**Addendum 1**

**Subject:** Robeson HS Fire Alarm Replacement Project  
SDP Contract No. B-055c 2020/21

**Location:** Paul Robeson High School  
11-19 South 42<sup>nd</sup> Street  
Philadelphia PA 19104

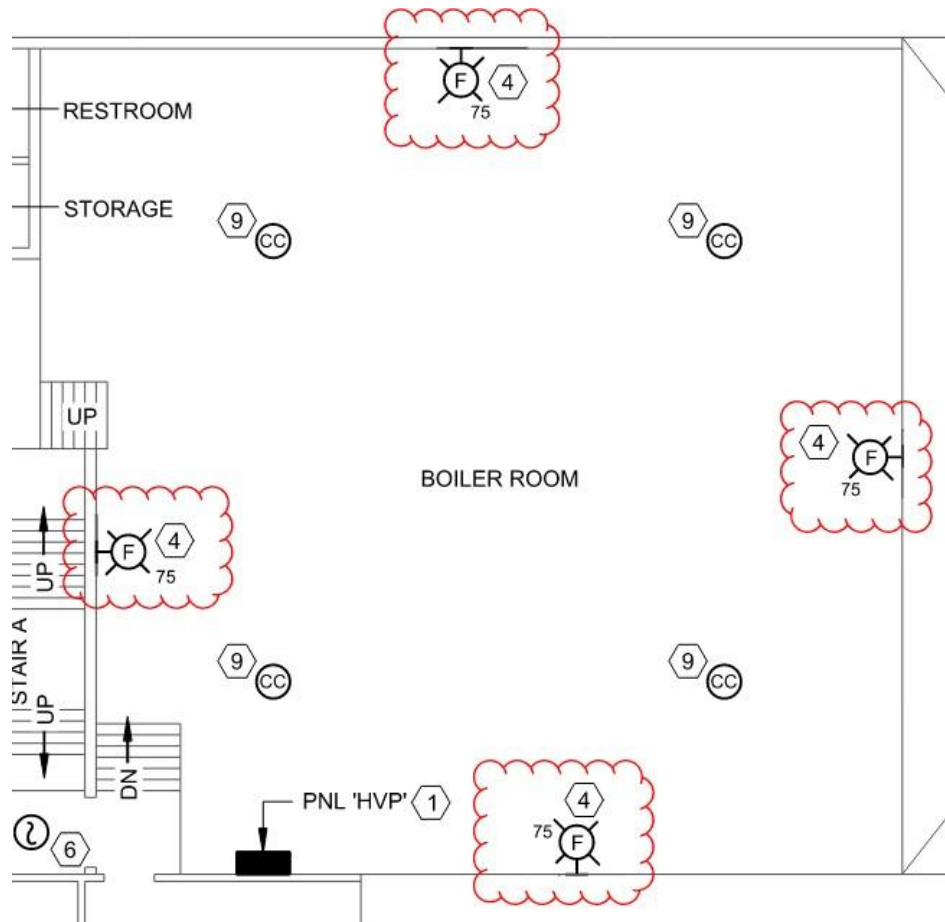
**Question #5:** Boiler Room: Does the boiler room require notification devices? None are shown.

- **Response: Yes, Refer to sketch below:**
